## Global Change Notification (GCN)

Product Family

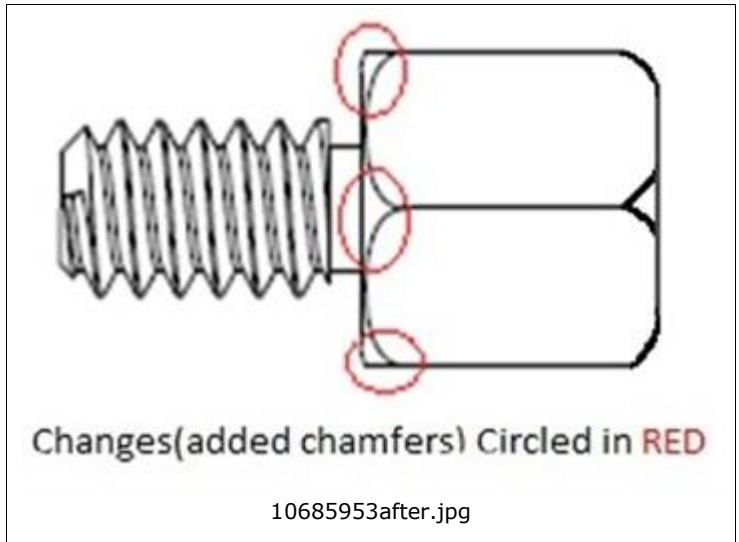
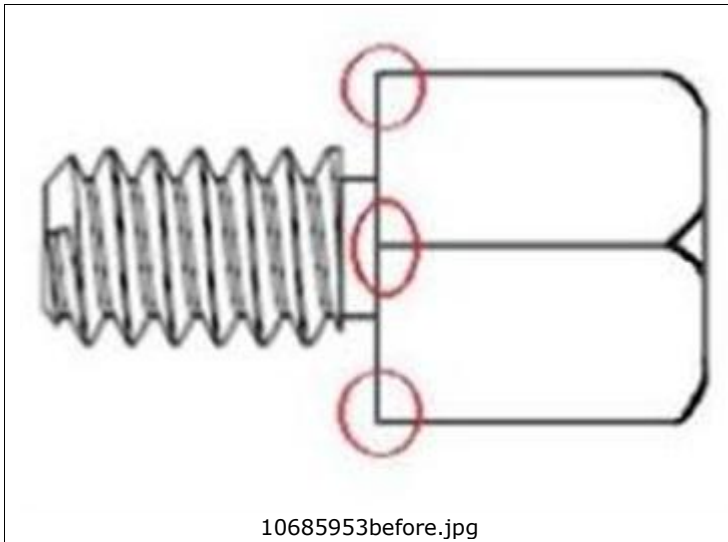
Change Description
